CITY OF PARKSVILLE
ADVISORY PLANNING COMMISSION

AGENDA

2. OCP & Zoning Amendment Application (272 Island Highway West)

DATE: April 22, 2010
TO: Gayle Jackson, Director of Community Planning
FROM: Marc Norris, Deputy Fire Chief
SUBJECT: OCP & Zoning Amendment Application - 272 Island Hwy. West
REFERENCE: Legal: Lot 1, District Lot 89, Nanoose District, Plan 5722, except parts in Plans 10153 and VIP52582 and Lot 1, District Lot 89, Nanoose District, Plan 10153
Civic: 272 Island Highway West
Registered Owner: 658780 B.C. Ltd., Inc. No. 658780
Applicant: Vincent Jandrisch
Planning File: 3360-10-02

SITE PLAN / EXISTING GRADES / EXISTING TREES

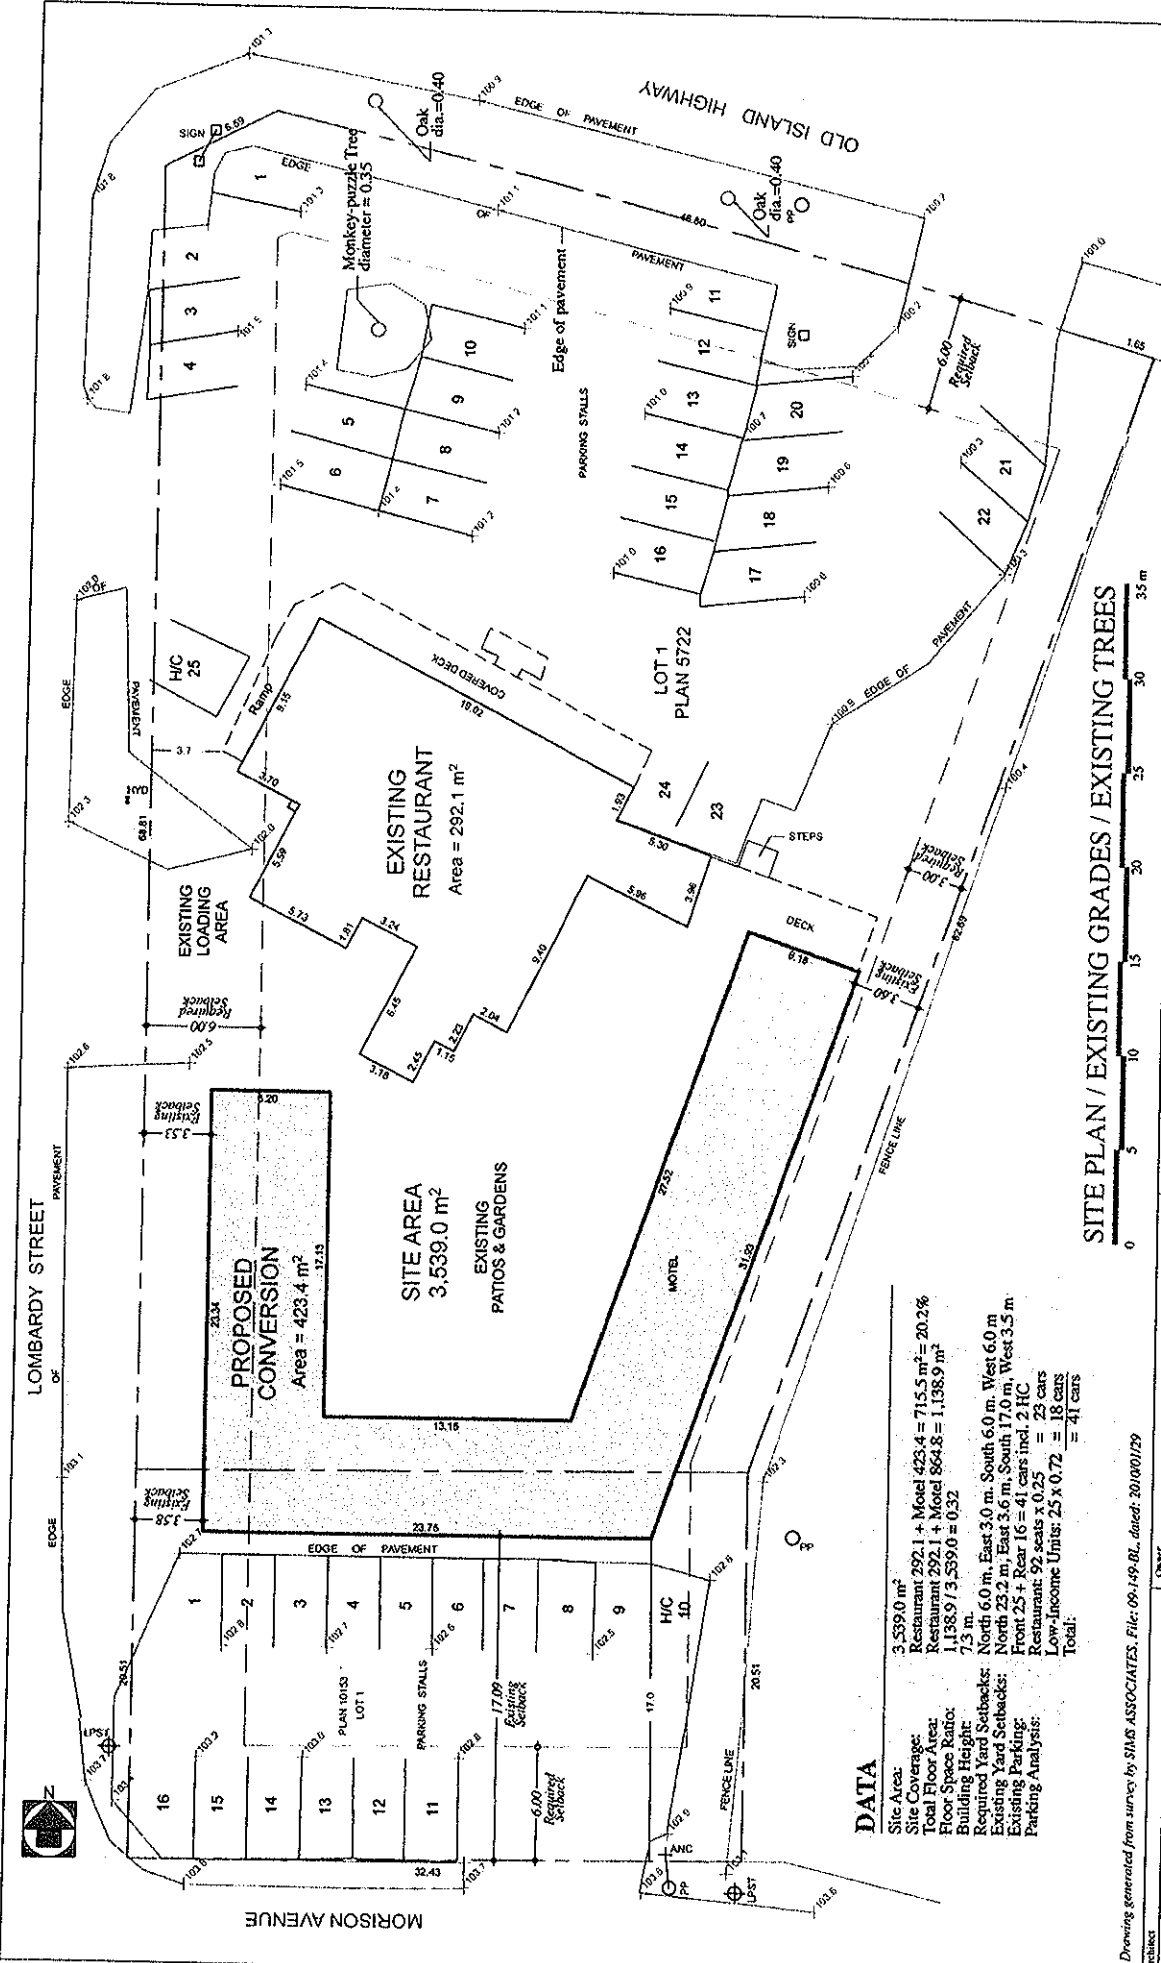
The Parksville Volunteer Fire Department has reviewed the site and floor plan(s) as provided with the above-noted zoning amendment application.

Fire flow calculation will be required. No fire flow calculations have been reviewed by the fire department at this stage. As is normal, the fire department will review these calculations in conjunction with the Engineering Department when the calculations are submitted. Comment will be provided to the engineering department at that time.

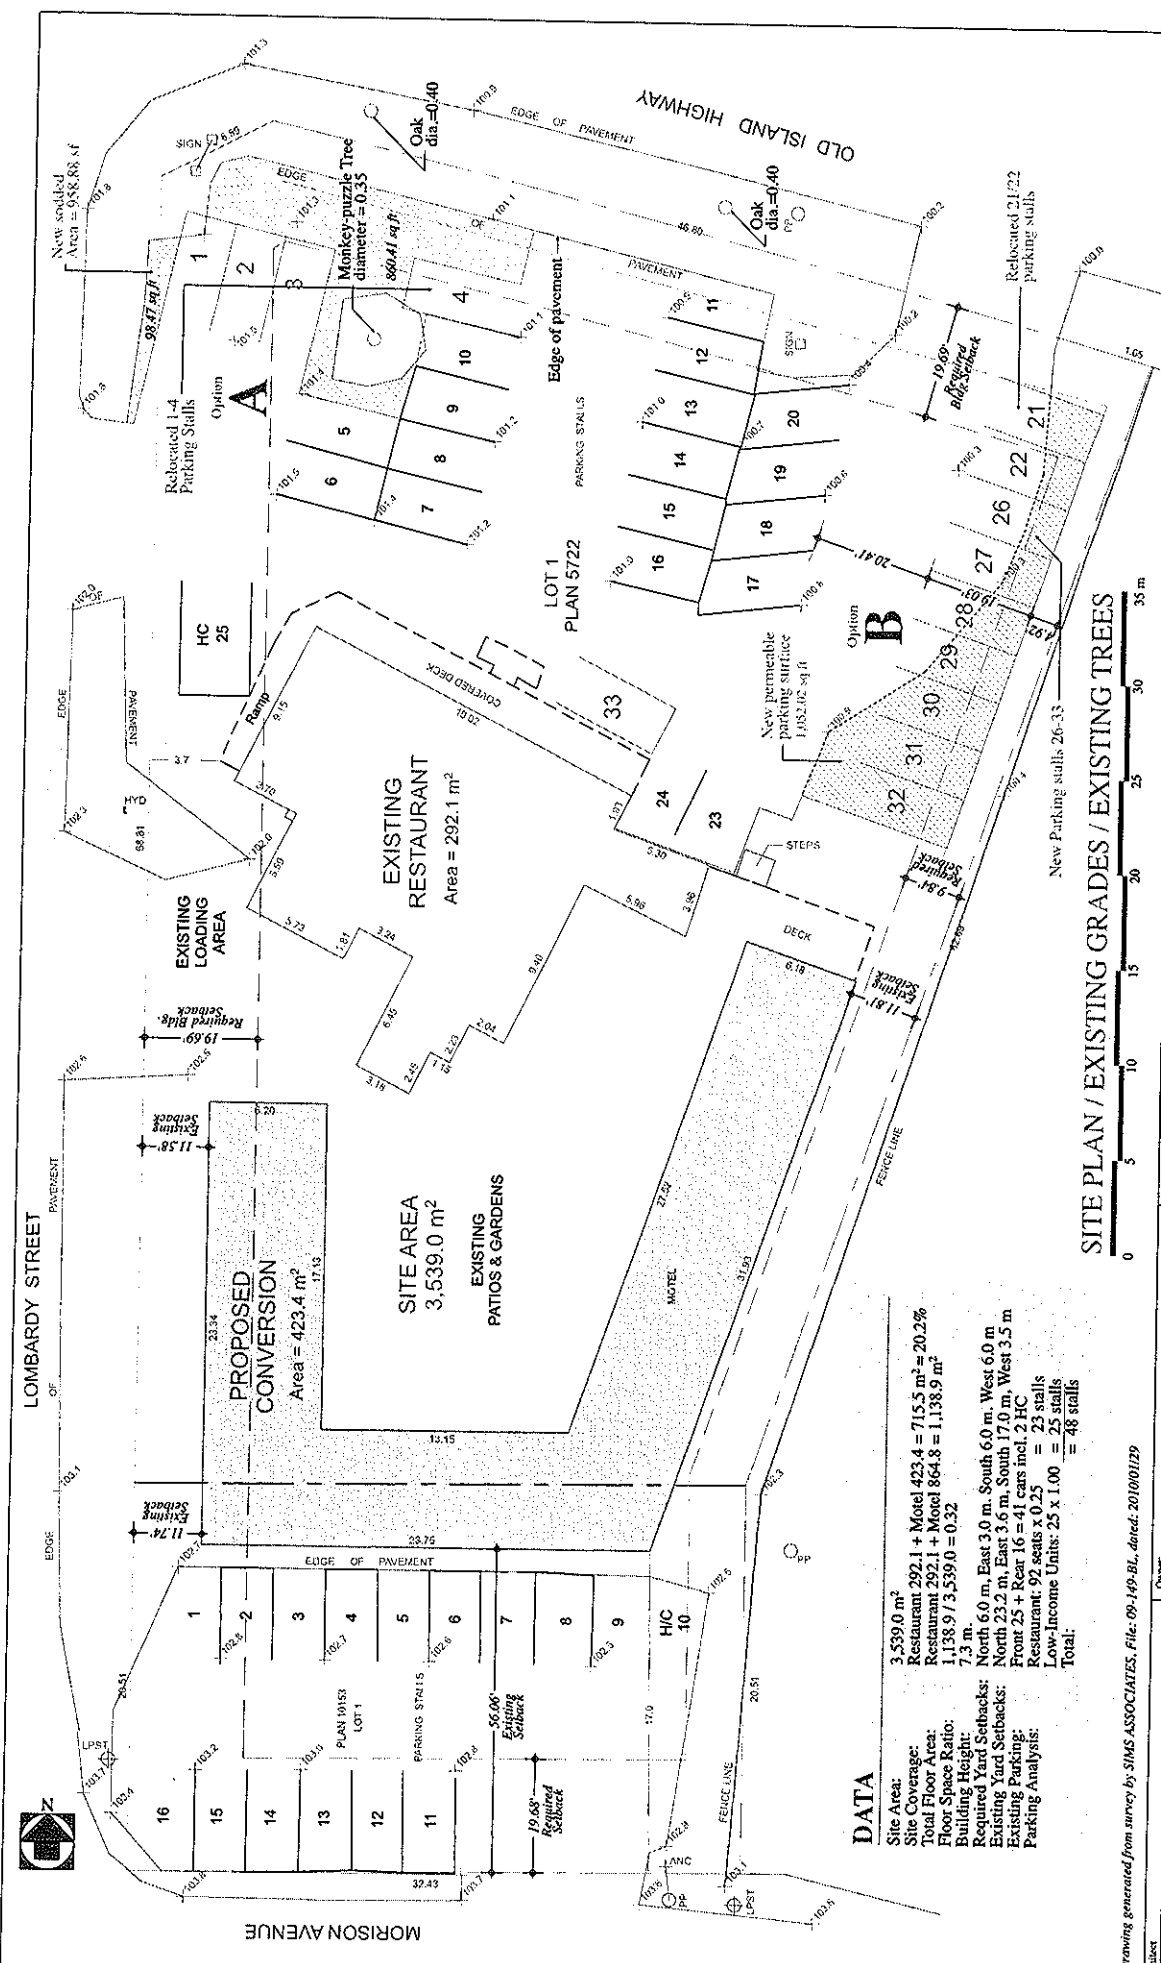
Specific items may include, but are not necessarily limited to -

- Demolition and construction fire safety plans;
- Locations of municipal and private fire hydrants;
- Inclusion of Sprinkler and Standpipe systems;
- Locations of fire safety system components such as fire department connections (FDC's), fire alarm & annunciator panel, sprinkler system valves, standpipes & hose valves, etc.;
- Layout and terminology used when assigning names for the labelling and/or programming of fire alarm panels, site & floor plans, and other fire safety appliances, systems or provisions;
- Fire safety and firefighting signage, including site and floor plans;
- Fire safety plan for the completed building;
- Stairwell identification and numbering;
- Fire smart landscaping;
- Civic addressing and internal numbering/naming scheme(s): A submission, showing the proposed civic addressing, building identification and unit numbering scheme, is requested.
